**TECHNICAL MEMORANDA
FOR OTHER SITES
SITE INVESTIGATIONS**

2 September 1994

Prepared for
United States Army Engineer District, Kansas City
CEMRC ED-TP
601 East 12th Street
Kansas City, Missouri 64105-2896

Prepared by
Louis Berger & Associates, Inc.
295 Promenade Street
Providence, Rhode Island 02908

Figure 1: Site Location and Proposed Monitoring Well Nest Locations

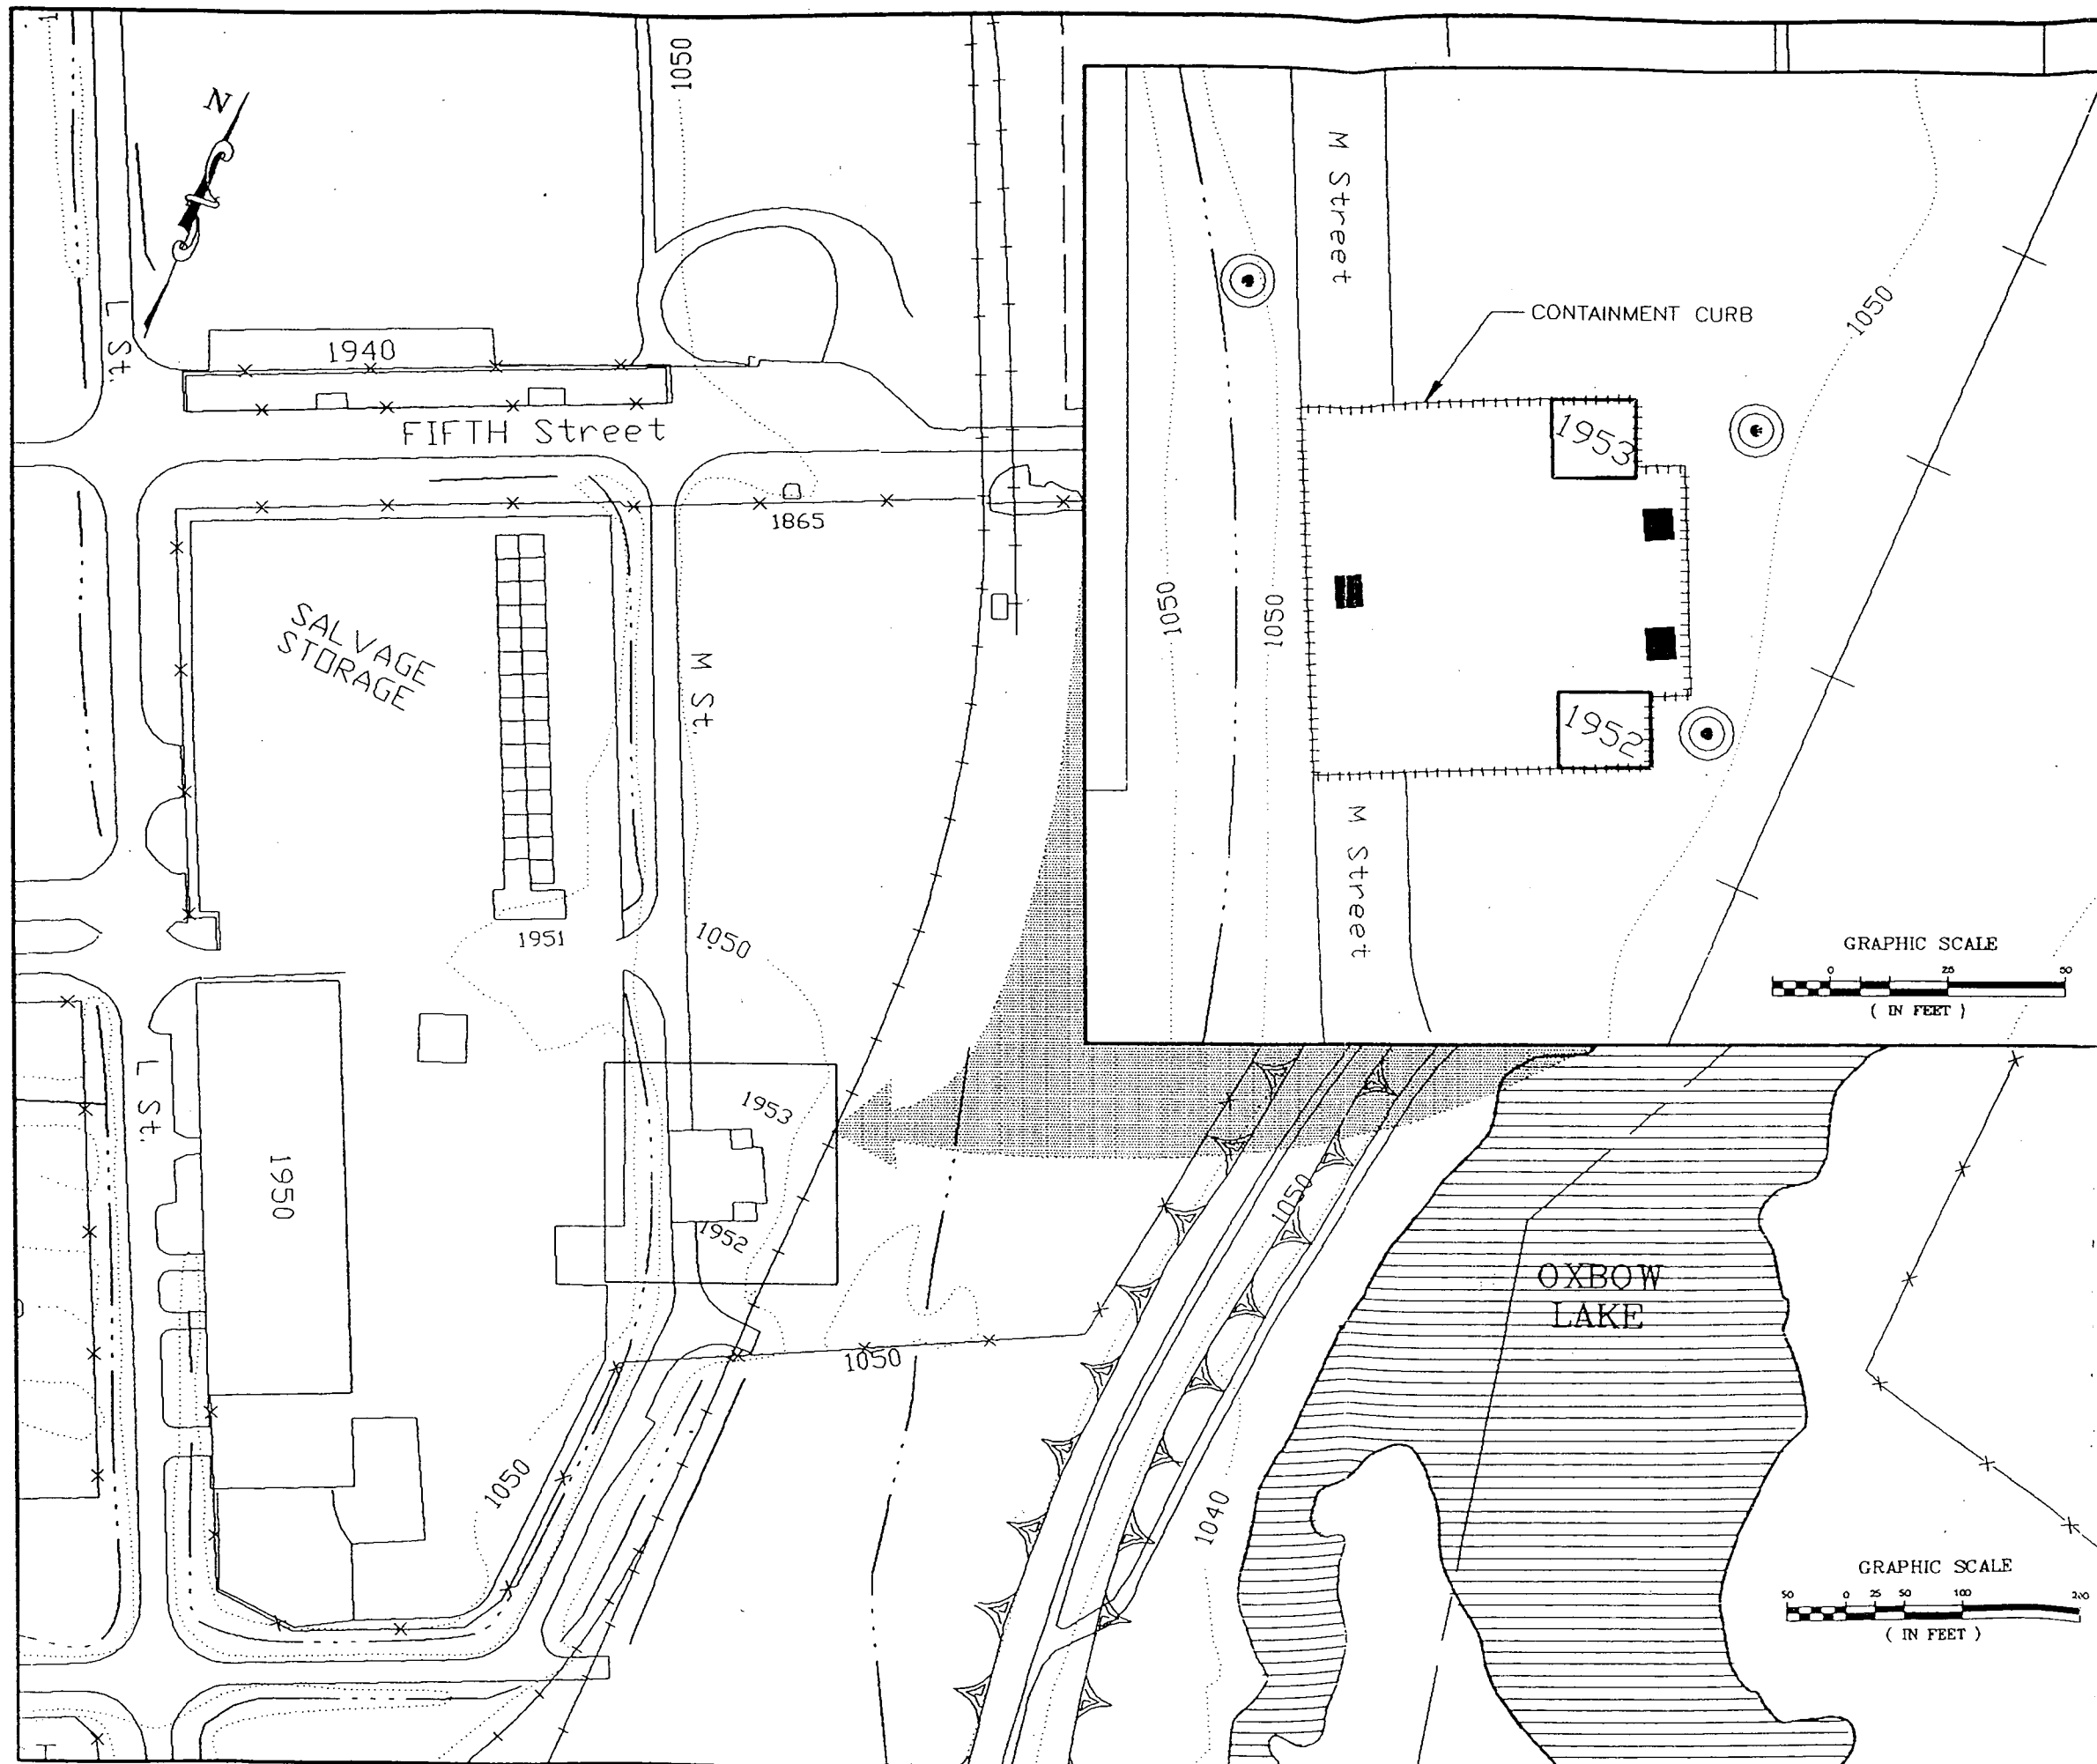
Six wells will be installed at the current DRMO facility as follows (see Figure 1):

- Two sets of nested (detection) wells immediately downgradient of Buildings 1952 & 1953

- One set of nested (background) wells upgradient of the DRMO

It is recommended that the downgradient well nests be placed as close as physically possible to the edge of hazardous waste management units. Downgradient wells should be placed on the east side of these buildings since the groundwater gradient is east toward the Kansas River. Temporary groundwater gradient reversals during periods of high flow in the Kansas River may occur but will not impact the ability of the downgradient wells to serve as an effective network for detecting releases to groundwater. The actual placement of these wells may vary from that shown on Figure 1 due to site conditions such as utilities, drill access, and railroad right-of-way. In particular, there is a variety of non-hazardous material storage in the areas outside and adjacent to buildings 1952 and 1953. If necessary, the downgradient nested wells will be moved further to the east due to this surface storage. These sets of nested downgradient wells will provide detection monitoring of both hazardous waste storage buildings due to the close proximity of the buildings.

Figure 3: Schematic Geologic Cross Section-
DRMO Hazardous Waste Storage Facility (Buildings 1952 and 1953)
Showing Proposed Groundwater Monitoring Well Nest Configuration

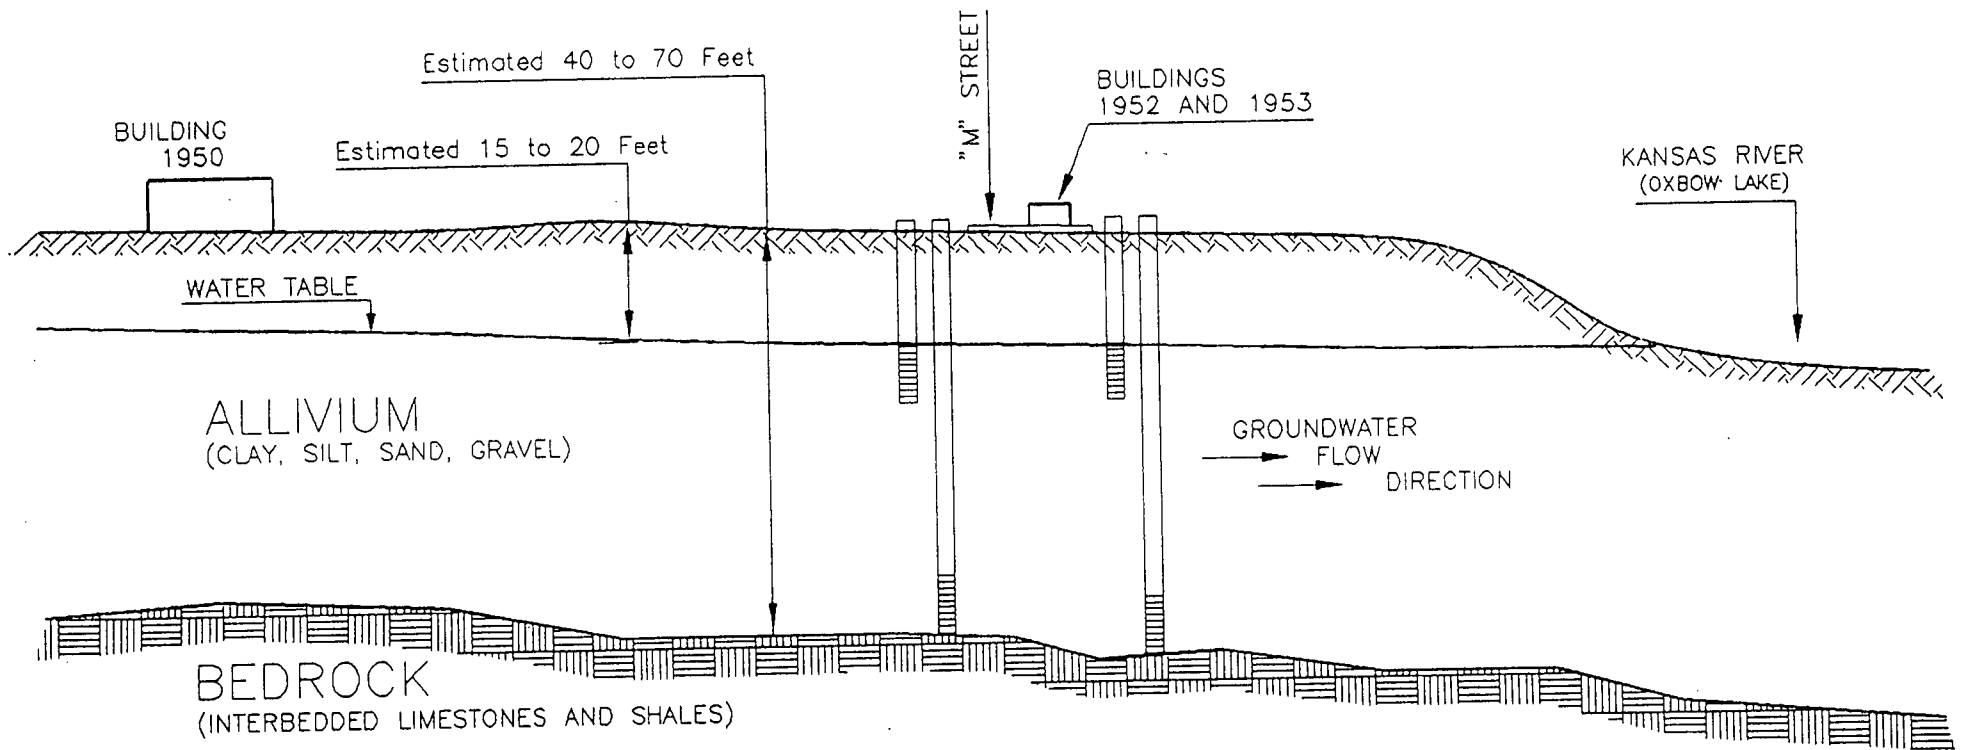
Nested wells are recommended for several reasons. Firstly, potential contaminants occurring at the site could either be dense, non-aqueous phase liquids (DNAPLs) (e.g., trichloroethylene -- TCE) or light, non-aqueous phase liquids (LNAPLs) (e.g., petroleum-based hydrocarbons). DNAPLs tend to sink in the aquifer while LNAPLs tend to float. Secondly, the unconsolidated materials in which the uppermost aquifer is found is likely to have a high vertical gradient. Well clusters are recommended in the EPA Guidance to establish vertical hydraulic gradient and the vertical distribution of contaminants.

We recommend that an upgradient well nest be installed to assess the quality of groundwater entering the site (i.e., background) in the upper and lower zones of the aquifer. It is proposed that this well nest be placed in the field west of the DRMO facility (see Figure 2).

Figure 13-1
 SAMPLING GRID-
 PRINT AND PUBLICATION
 SHOP

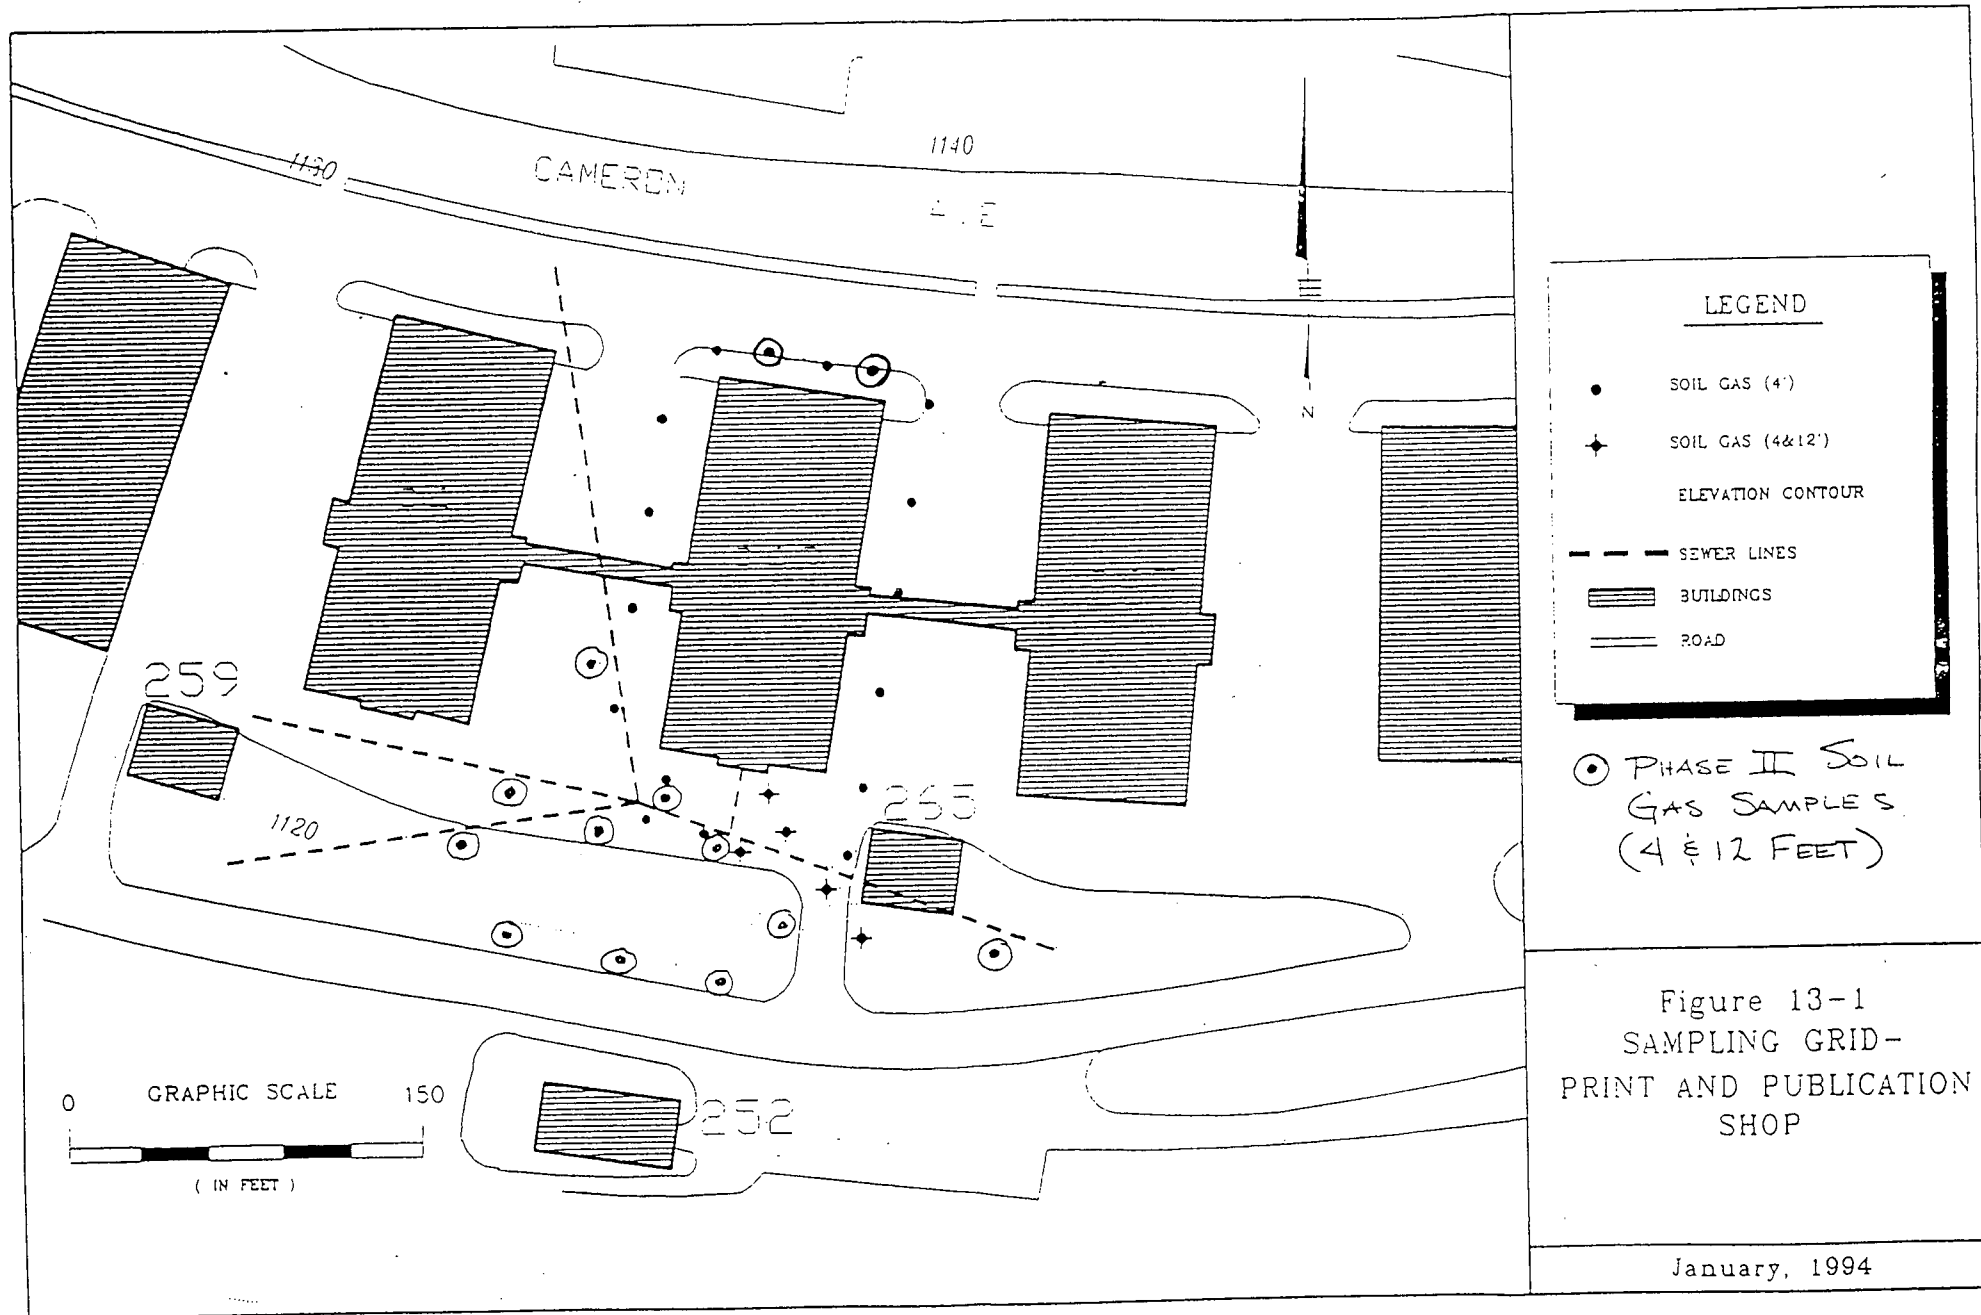
The positive detections in the Phase I soil gas survey occur primarily along the sewer line running to the south of the Print and Publication Shop. Therefore, Phase II soil gas points are located as follows:

- one on each of the three sewer lines feeding into the line south of the Print and Publication Shop, with the samples located upflow of the junction;
- three locations at and around the junctions of the sewer lines south of the building;
- one location on the downflow end of the sewer line leaving the Print and Publication Shop; and
- four locations on the downgradient side (to the south) of the area with the positive detections.

In addition, petroleum hydrocarbons were detected at one location in the rear of the building. Two Phase II locations are located on either side of this Phase I location. As outlined in the SAP, the Phase II sample locations will include soil gas samples at both the 4 foot and 12 foot depths. The locations of the Phase II samples are shown on the attached site sketch. These sample locations were approved by the parties to the IAG based on a facsimile transmission of relevant information on 7 March 1994. The Phase II survey was conducted on 8 and 9 March, and the Phase II results were reported in the weekly report dated 11 March 1994.
